NOTICE OF ADDENDUM  
 ADDENDUM NO. 2  
 CONTRACT NO. 7843  
 RONALD REAGAN AVENUE, JOHN WALL DRIVE AND MERCHANT STREET  
 ASSESSMENT DISTRICT – 2017

PROJECT NAME:	Ronald Reagan Avenue, John Wall Drive and Merchant Street Assessment District - 2017
CONTRACT NO.:	7843
SBE GOAL	12%
BID BOND	5%
SBE PRE BID MEETING (1:00 P.M.)	February 2, 2018
PREQUALIFICATION APPLICATION DUE (2:00 P.M.)	February 7, 2018
BID SUBMISSION (2:00 P.M.)	February 14, 2018
BID OPEN (2:30 P.M.)	February 14, 2018
PUBLISHED IN WSJ	January 25 & February 1 & 9, 2018

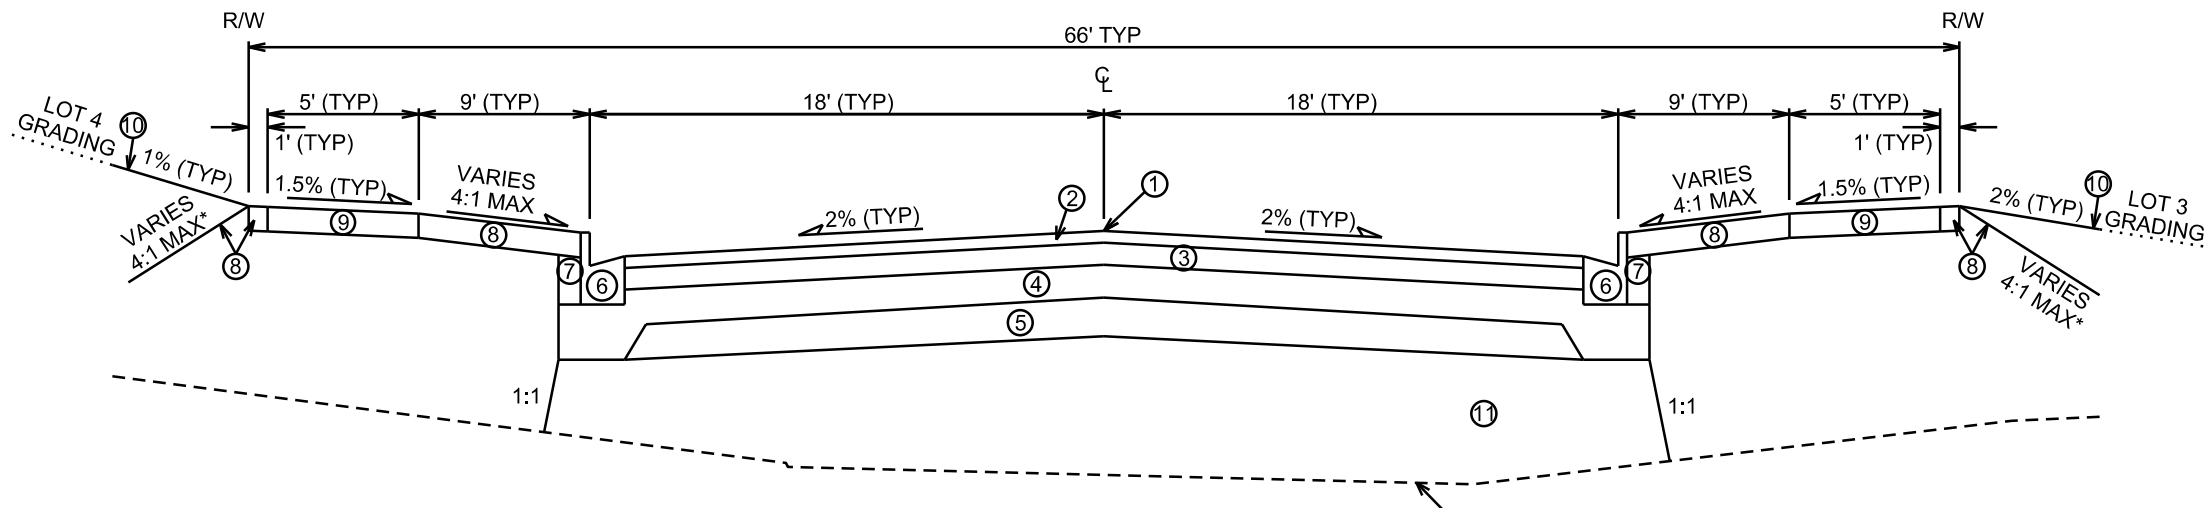
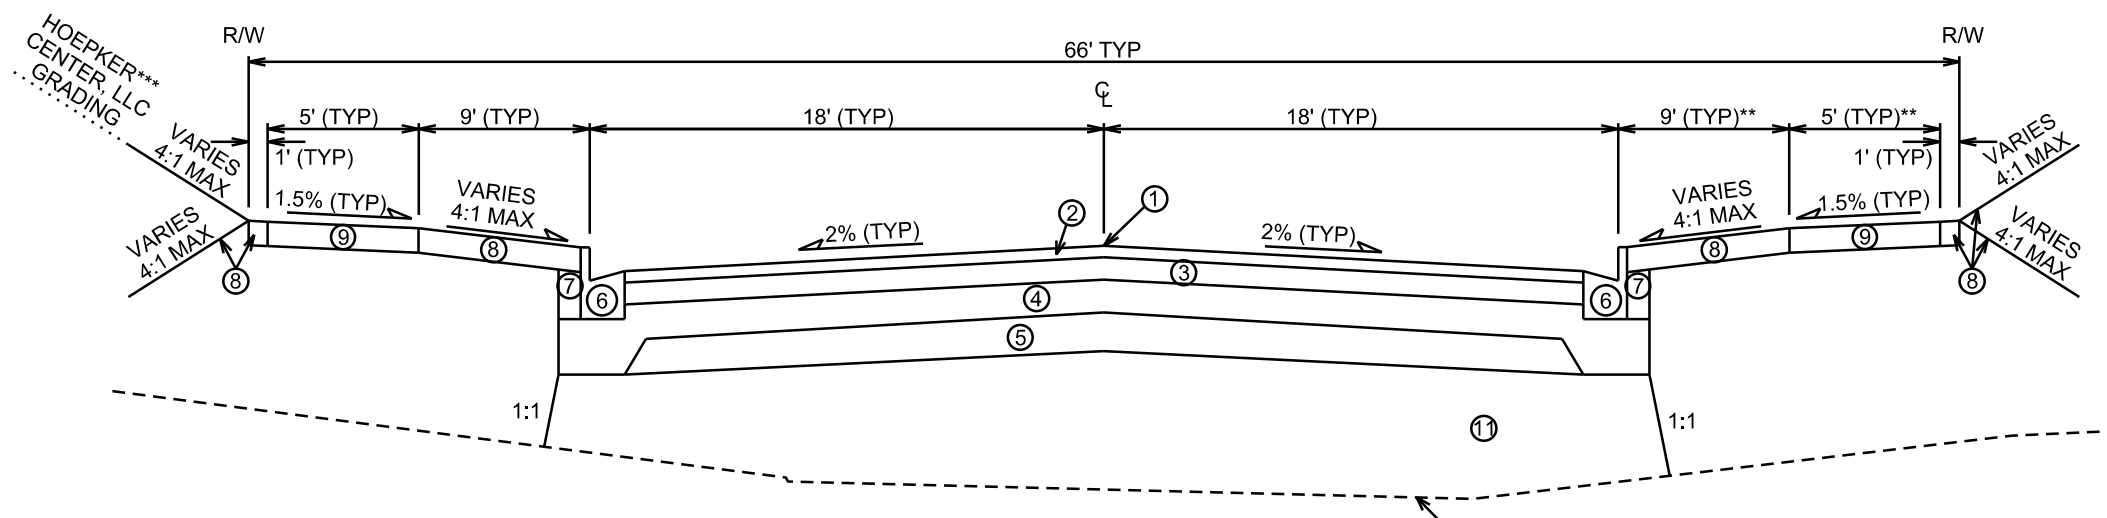
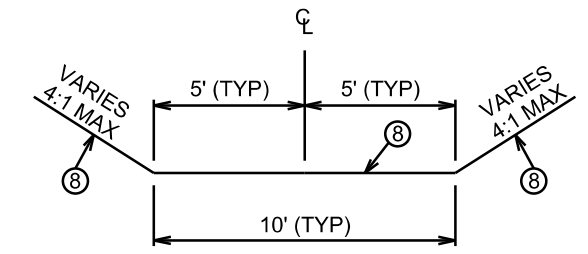
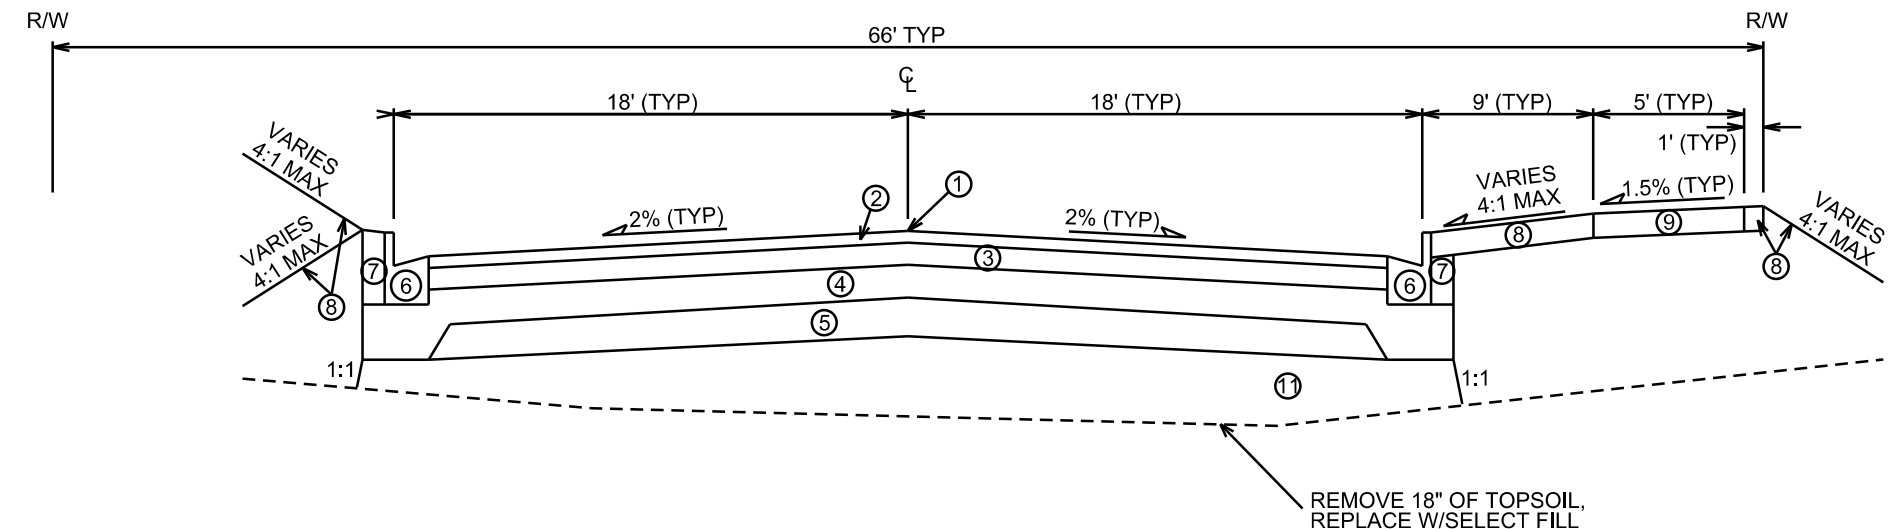
D-1: Updated call off #2 with the asphalt upper layer and #3 lower layer mixtures.

- ① POINT REFERRED TO ON PROFILE
- ② 2" BITUMINOUS UPPER LAYER, 4 MT 58-28 H
- ③ 3 1/4" BITUMINOUS LOWER LAYER, 3 MT 58-28 H
- ④ 4" GRADATION 2 CRUSHED STONE
- ⑤ 6" GRADATION 1 CRUSHED STONE
- ⑥ TYPE 'A' CONCRETE CURB & GUTTER
- ⑦ FILL BORROW
- ⑧ 6" TOPSOIL, TERRACE SEED AND EROSION MAT
- ⑨ 5" CONCRETE SIDEWALK
- ⑩ TEMPORARY SEED
- ⑪ SELECT FILL

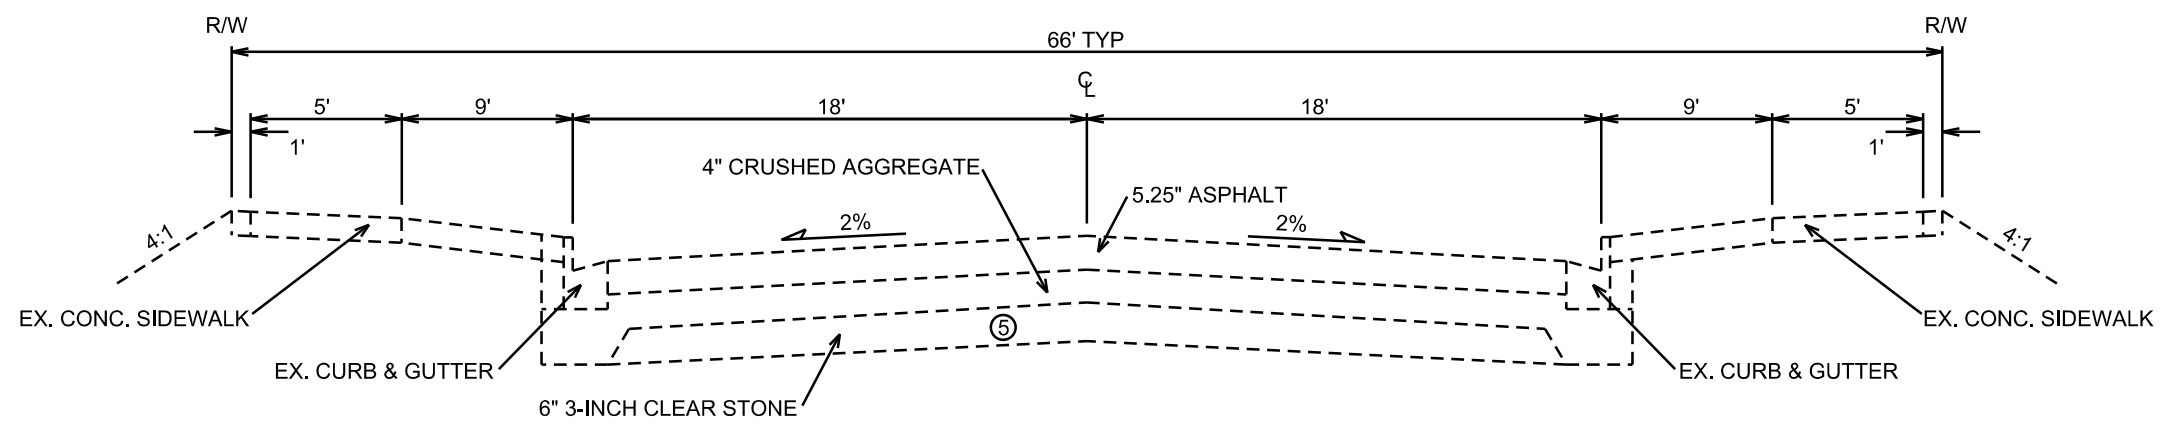
D-2: Updated call off #2 with the asphalt upper layer and #3 lower layer mixtures.

- ① POINT REFERRED TO ON PROFILE
- ② 2" BITUMINOUS UPPER LAYER, 4 MT 58-28 H
- ③ 3 1/4" BITUMINOUS LOWER LAYER, 3 MT 58-28 H
- ④ 4" GRADATION 2 CRUSHED STONE
- ⑤ 6" GRADATION 1 CRUSHED STONE
- ⑥ TYPE 'A' CONCRETE CURB & GUTTER
- ⑦ FILL BORROW
- ⑧ 6" TOPSOIL, TERRACE SEED AND EROSION MAT
- ⑨ 5" CONCRETE SIDEWALK
- ⑩ TEMPORARY SEED
- ⑪ SELECT FILL
